APPROVING CHANGE ORDER NO. 5 WITH CRAMER AND ASSOCIATES, INC. FOR ADDITIONAL WORK ON RIVERWALK RED MULTI-USE TRAIL BRIDGE REHABILITATION, IN AN AMOUNT NOT TO EXCEED \$105,835

Change Order # 5
12-2014-007

INSTRUCTION TO CONTRACTOR No. 1

SUBJECT: Red Bridge Superstructure
Corrosion

Location 1 – Main Girder Connection to Pier 2 Transverse Plate Diaphragm

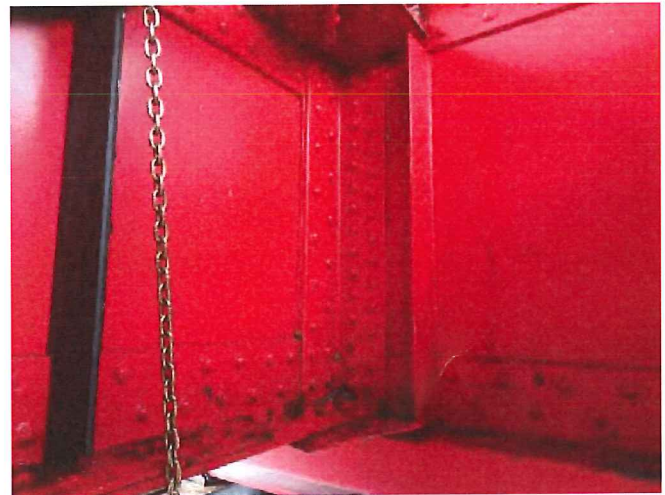
Near the top of primary girder flanges, at the connection to the transverse plate diaphragm, a riveted steel angle shows section loss. There is significant corrosion, the angle is bent, and several rivets are missing.

At multiple times during the life of the railroad bridge, the superstructure was strengthened with additional plates and angles to account for the increased weight of trains. The main steel members in railroad bridges are typically simply supported girders to simplify design and analysis. The web and bottom flange connections are in relatively good condition compared to the angle at the top, which is exposed to rainfall and corrosion more than other areas. It appears as if the start of corrosion, missing rivets, and bending of the top angle date to the railroad use period, prior to the 2005 renovation.

- Remove loose debris from top connecting angles and top of girders.
- Using hand tools, cut out from the top connecting angle flaking and projecting rust along neat horizontal and vertical lines.
- Perform a light air blast clean, followed by a high pressure water blast.

- Assess condition in the field of exposed steel. Use 1/8" seal weld as required to limit infiltration of water into concealed areas.
- Prime and paint the areas where paint has been removed and repairs have been made in accordance with Specification Section 09900 Painting.
- Method of Measurement for "Location 1 Repair" shall be for each girder for a quantity of 2. Payment shall be full compensation for the all work listed in these Recommendations for Location 1.

EAST ABUTMENT DETAILS - SHEET I

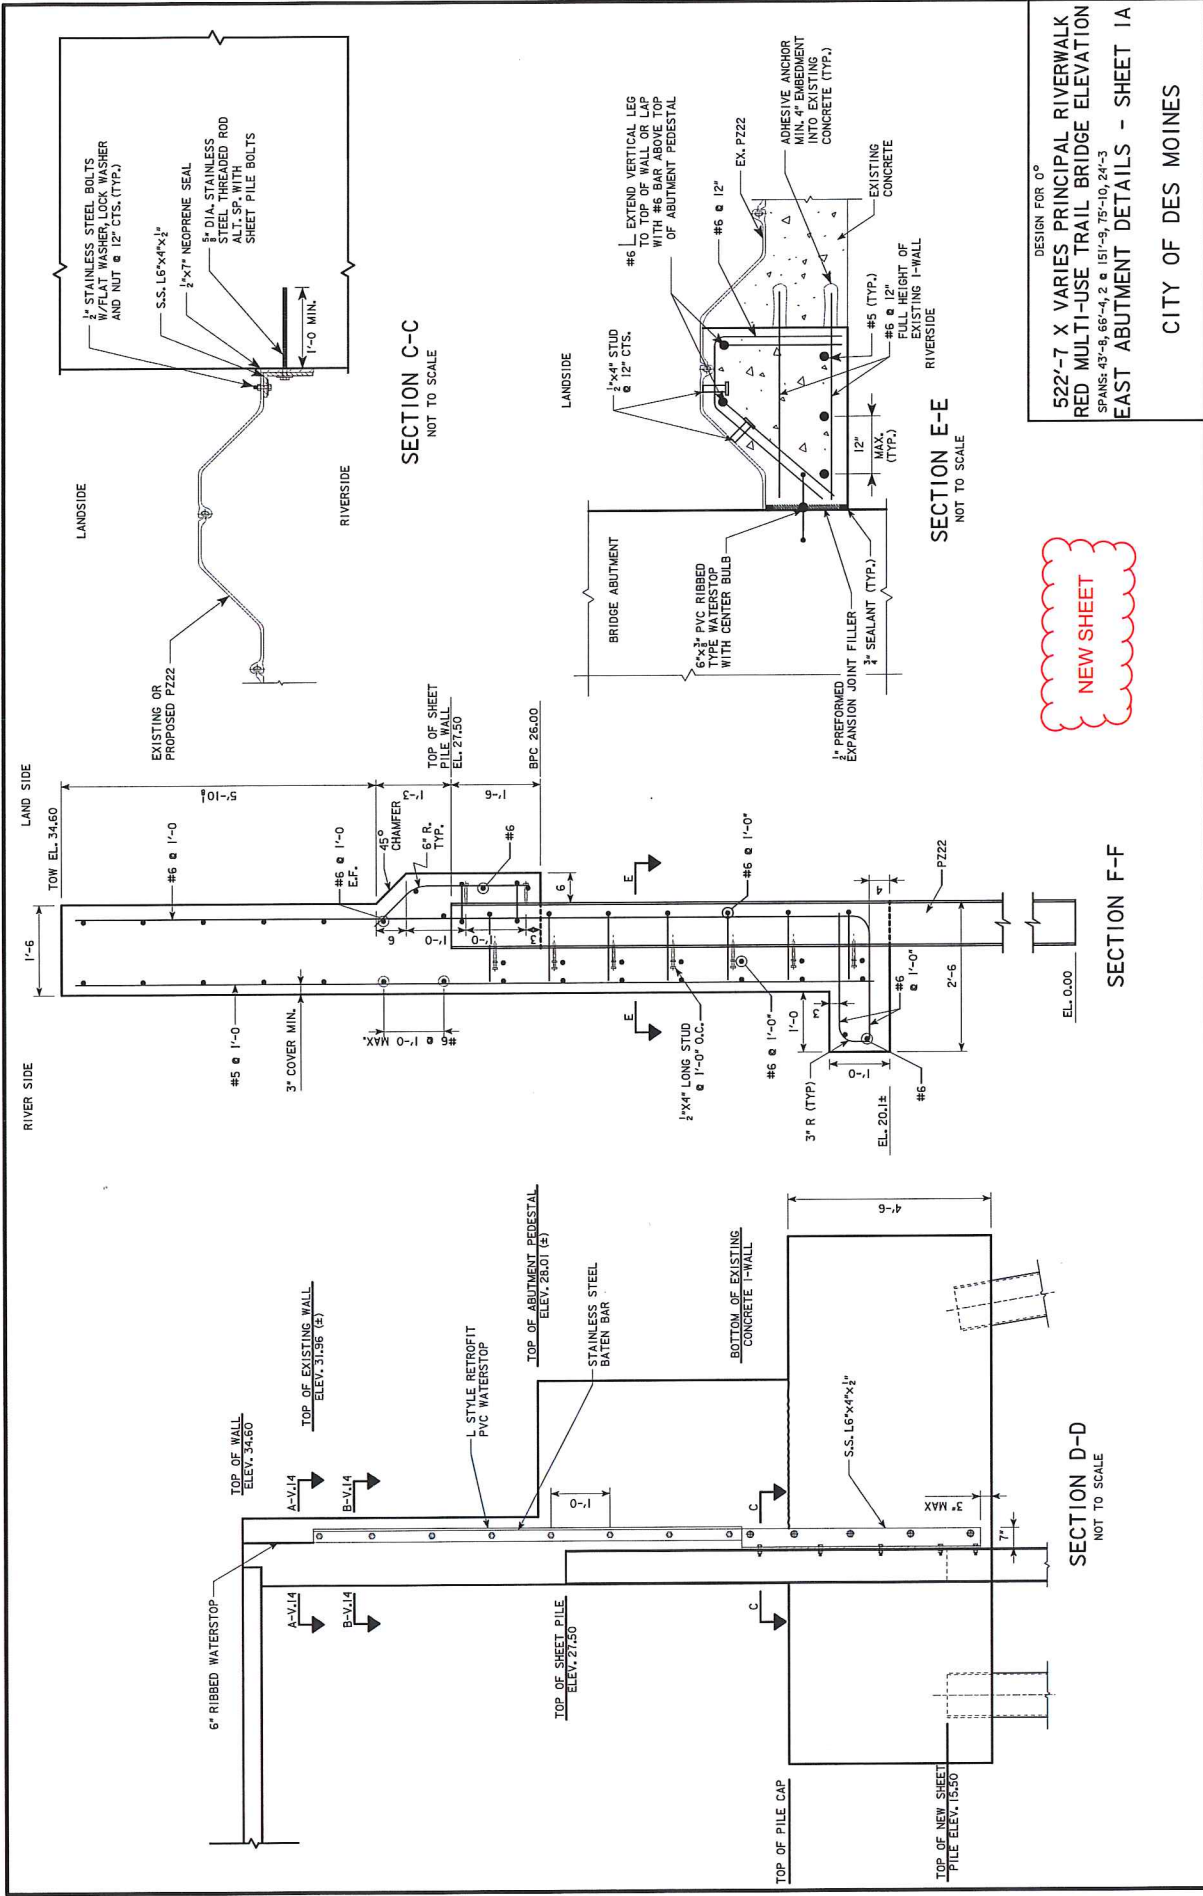
DATE	SHEET NUMBER	DESCRIPTION OF REVISIONS	DATE	SHEET NUMBER	DESCRIPTION OF REVISIONS
02-06-2017	A.1A	REVISION SHEET ADDED.			
02-06-2017	C-1	QUANTITIES REVISION TO QUANTITIES AS REQUIRED FOR REVISED SHEET PILE AND CONCRETE I-WALL DETAIL ADJACENT TO EAST ABUTMENT.			
02-06-2017	C-3	ESTIMATE REFERENCE NOTES REASON: ADDED ESTIMATE REFERENCE NOTE FOR "REMOVAL OF CONCRETE".			
02-06-2017	V.14	EAST ABUTMENT DETAILS - SHEET 1 REASON: REVISED SHEET PILE AND CONCRETE I-WALL DETAIL ADJACENT TO EAST ABUTMENT.			
02-06-2017	V.14A	EAST ABUTMENT DETAILS - SHEET 1A ADDED REASON: ADDITIONAL DETAILS FOR REVISION TO SHEET PILE AND CONCRETE I-WALL ADJACENT TO EAST ABUTMENT.			
02-06-2017	V.15	EAST ABUTMENT DETAILS - SHEET 2 REASON: REVISED SECTION E-E FOR REVISED DETAILS TO SHEET PILE AND CONCRETE I-WALL ADJACENT TO EAST ABUTMENT.

- REMOVE EXISTING CONCRETE PROTRUDING PAST FACE OF WALL AND REINFORCING BARS FROM EXISTING CONCRETE. REINFORCING BARS SHALL BE REMOVED USING SAW CUTS LEAVING WALL FREE OF CRACKS. SEE "REMOVAL NOTES" ON SHEET V-5.
- BRIDGE NOT SHOWN FOR CLARITY.
- NEW TOP OF ABUTMENT PEDESTAL ELEVATION DETERMINED BY NEW TOP OF DECK ELEVATION OF 34.60 FEET. CONTRACTOR TO FIELD VERIFY ELEVATIONS.
- REMOVE PORTION OF SHEET PILE ABOVE ELEV. 15.50 AND SEAL JOINT BETWEEN SHEET PILE AND ABUTMENT USING SECTION E-E. AT CONTRACTOR'S OPTION EMBED REPLACEMENT PZ22 INTO CONCRETE ABUTMENT MIN. 6" AND BURN HOLES TO INSTALL PERFORATING REINFORCING BARS. BURN HOLES SHALL BE MINIMUM WIDTH OF EACH HOLE IN SHEET PILE SHALL BE MINIMUM REQUIRED TO PASS INDIVIDUAL BAR.
- REINFORCE CONCRETE I-WALL PER SECTION E-E AND F-F ON SHEET V-14A.
